Title of Change:	PQFN56 Dual Cool Marking Layout Update
Effective date:	06 Dec 2022
Contact information:	Contact your local onsemi Sales Office or KrisJudelo.Dayna@onsemi.com
Type of notification:	This Product Bulletin is for notification purposes only. onsemi will proceed with implementation of this change upon publication of this Product Bulletin.
Change Category:	Marking
Change Sub-Category(s):	Shipping/Packaging/Marking

Character Measurement Change

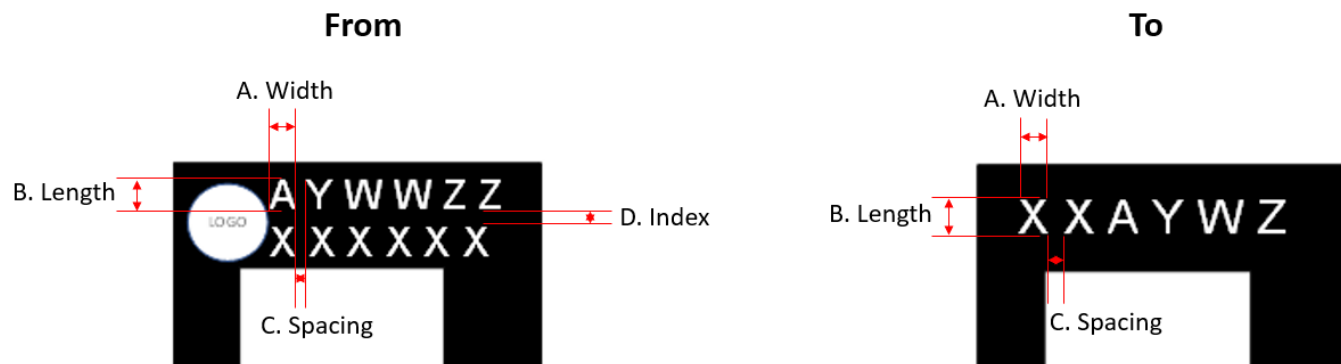
From	To
A. Width	0.36 mm	0.41 mm
B. Length	0.47 mm	0.64 mm
C. Spacing	0.08 mm	0.19 mm
D. Index	0.05 mm	NA

Note: Measurement are estimated values.
